CHAMPION AEROSPACE, INC.

# SERVICE LETTER

NUMBER: SL28VS200Y4DH-24-04-001

**SUBJECT:** Electrical Power - DC Generation - Transformer Rectifier Unit (TRU) Fan Motor Upgrade

Figure 1. Original Fan Motor Assembly Removal

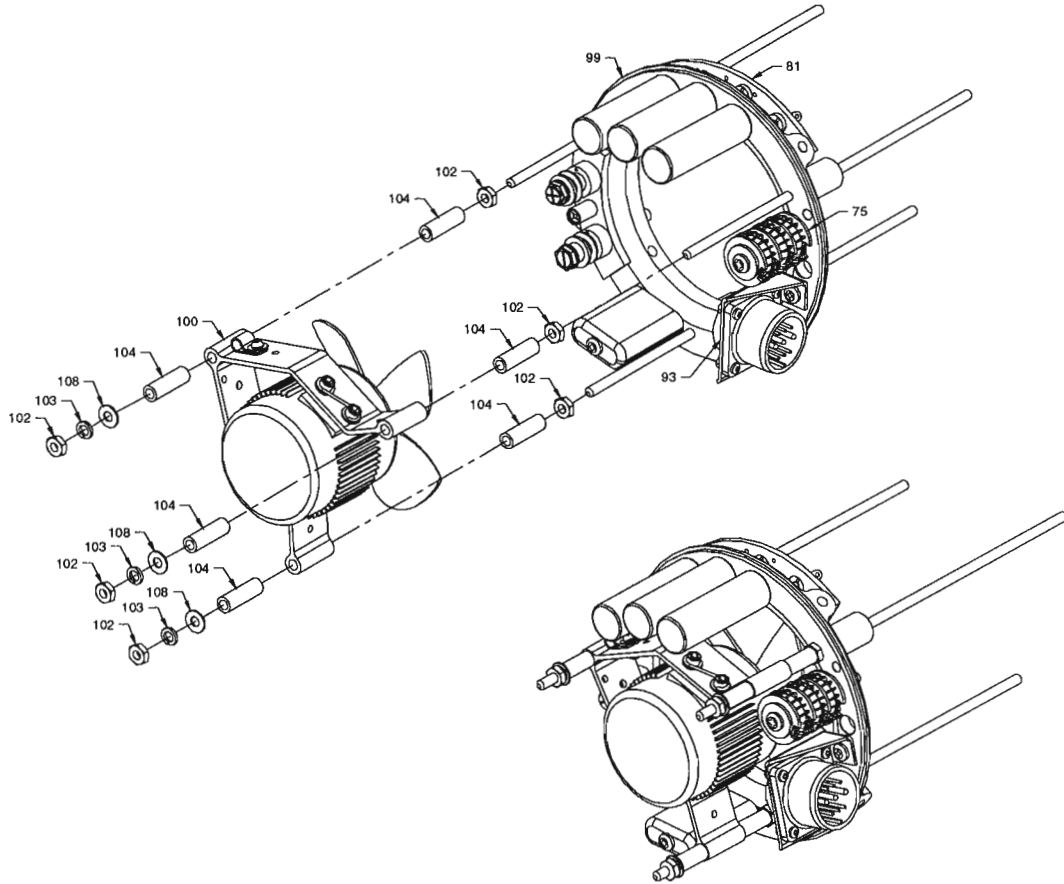
B. Disassembly - Remove Original Fan Motor Assembly (P/N:2561613).

NOTE: During removal of original fan motor assembly, it is not necessary to remove the input connector (93) or the reactor (75).

- (1) Remove mounting base (3), end bell (1) case assembly (6) and Nomex paper (if supplied) in accordance with IPL, Figure 1 of Component Maintenance Manual 24-31-46.
- (2) Remove original fan motor assembly (100) wire lugs (112) from AC Terminal Board (81).
- (3) Remove three nuts (102), three lockwashers (103), three flat washers (108) and three spacers (104) from original fan motor assembly (100) as illustrated in Figure 1.
- (4) Remove original fan motor assembly (100) from tie bolts (101).
- (5) Remove remaining three spacers (104) and nuts (102) from tie bolts (101).

Figure 2. New Fan Motor Assembly Installation.

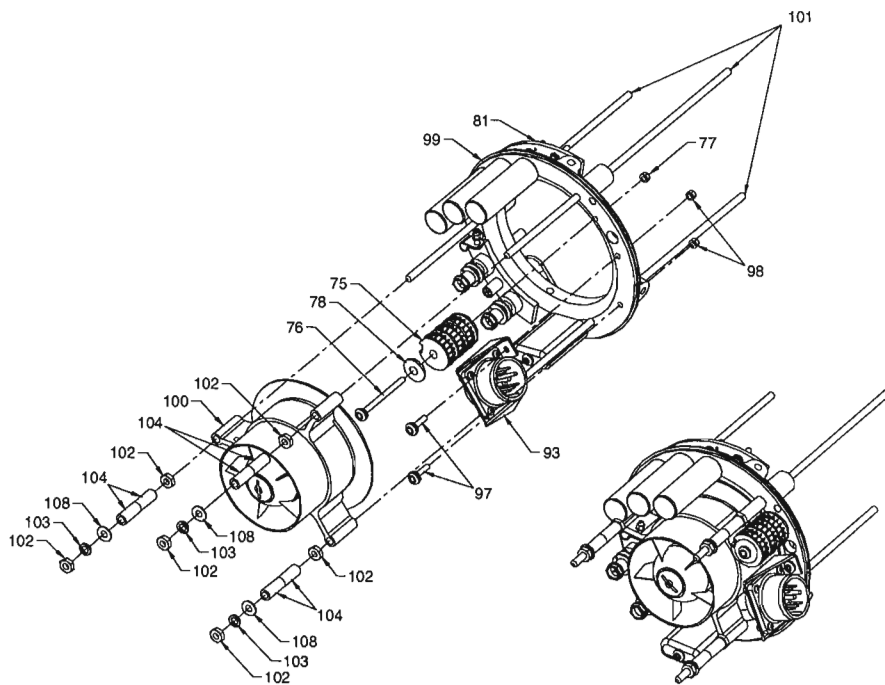
**NOTE:** Prior to assembly of new fan motor assembly, it is necessary to move the input connector (93) and reactor (75) aside. Desoldering the electrical connections is not required. Refer to Figure 2.

- (1) Remove two screws (97) and two nuts (98) securing input connector (93) to motor ring (99) and set input connector (93) aside.
- (2) Remove screw (76), washer (78) and nut (77) securing reactor (75) to motor ring (99) and set reactor (75) aside.

- (3) Install new fan motor assembly (100) (P/N: 2031526) onto tie bolts (101).
- (4) Assemble three plain nuts (102) onto tie bolts (101) immediately following the new fan motor assembly (100). Torque to 24-26 in-lbs.

- (5) Install six spacers (104), three flat washers (108), three lockwashers (103) and three plain nuts (102) onto tie bolts (101). Torque to 24-26 in-lbs.

- (6) Position reactor (75) onto motor ring (99) and install screw (76), washer (78) and nut (77).
- (7) Position input connector (93) onto motor ring (99) and install two screws (97) and two nuts (98).

Figure 3. New Fan Wire Routing and Locations.

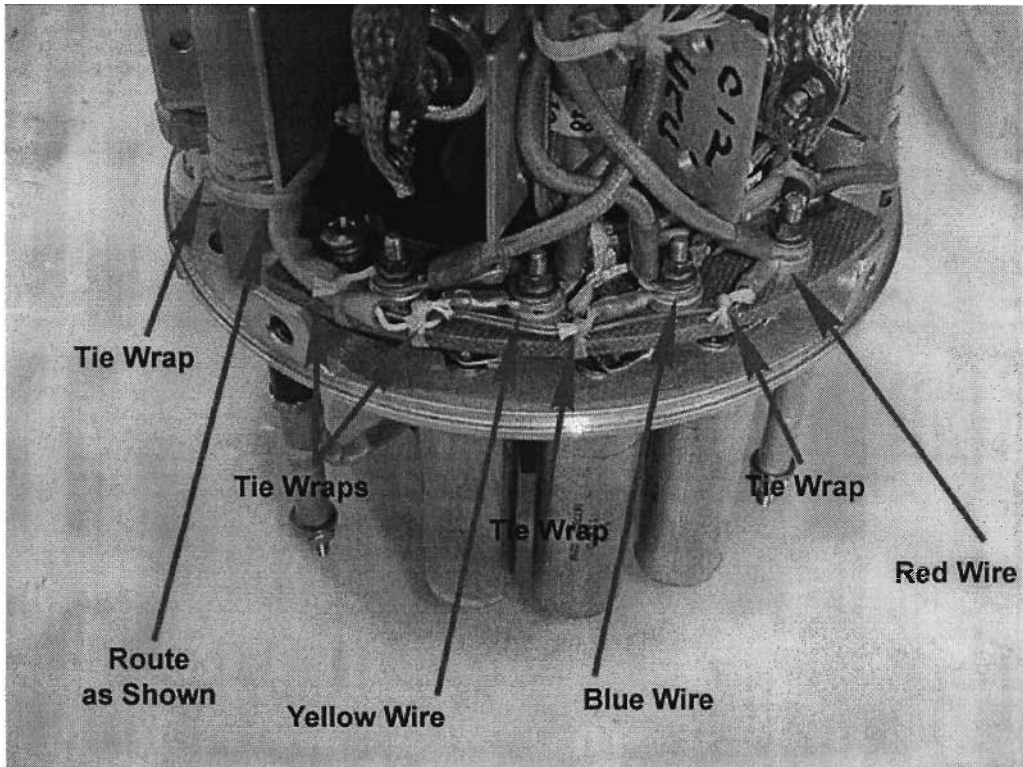
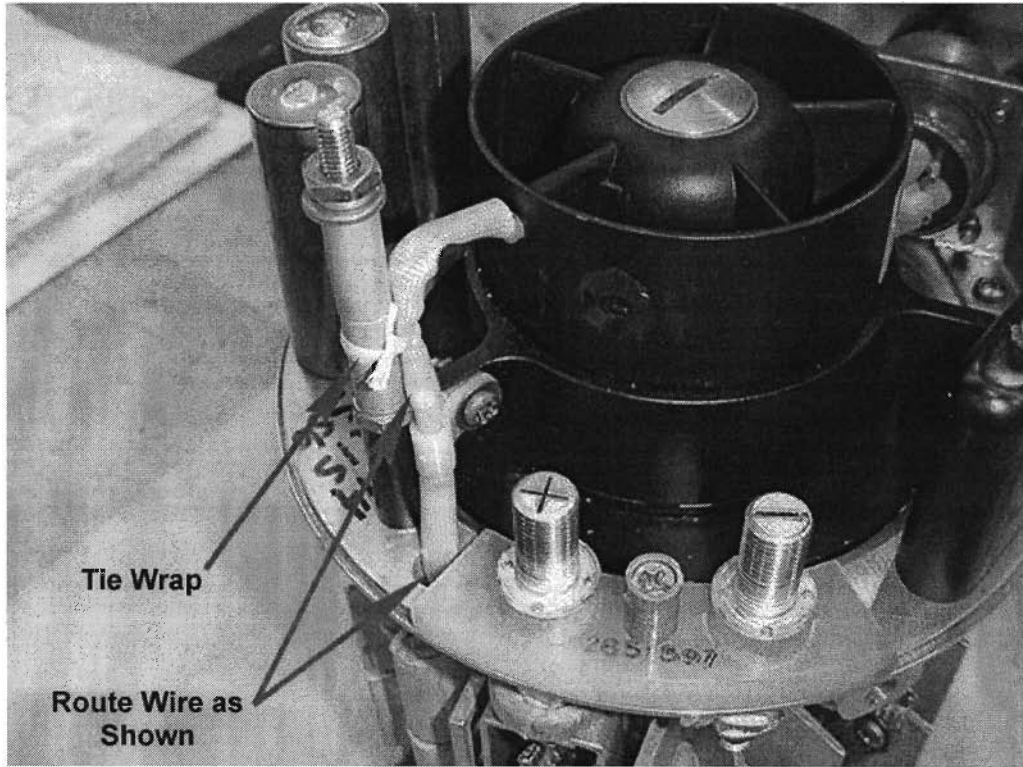
- (8) Install fan wire lugs (112) from new fan motor assembly (100) (P/N: 2031526), to AC terminal board (81). See Figure 3 for view of proper wire routing and termination.
